Well Name: PHOEBE COM	Well Location: T24N / R10W / SEC 22 / NWNW / 36.304006 / -107.889456	County or Parish/State: SAN JUAN / NM
Well Number: 90	Type of Well: OTHER	Allottee or Tribe Name:
Lease Number: NMNM100808	Unit or CA Name: FRCL PHOEBE	Unit or CA Number: NMNM119013
US Well Number: 300453405300S1	Operator: DUGAN PRODUCTION CORPORATION

Type of Submission: Notice of Intent

Type of Action: Plug and Abandonment

CONDITIONS OF APPROVAL

Planned P & A Wellbore Schematic

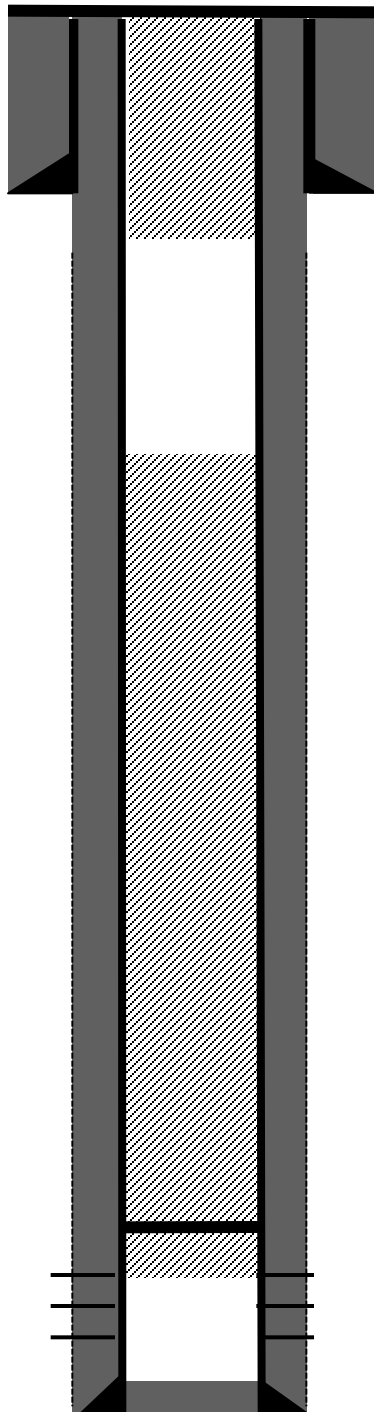
1. Plugging operations authorized are subject to the attached "General Requirements for Permanent Abandonment of Wells on Federal and Indian Lease."
2. The following modifications to your plugging program are to be made:
 - a. Operator selected formation tops are appropriate. No changes to the procedure.
3. **Notification:** Farmington Office is to be notified at least 24 hours before the plugging operations commence at (505) 564 7750.

Operator selected formation tops are appropriate. No changes to the procedure.
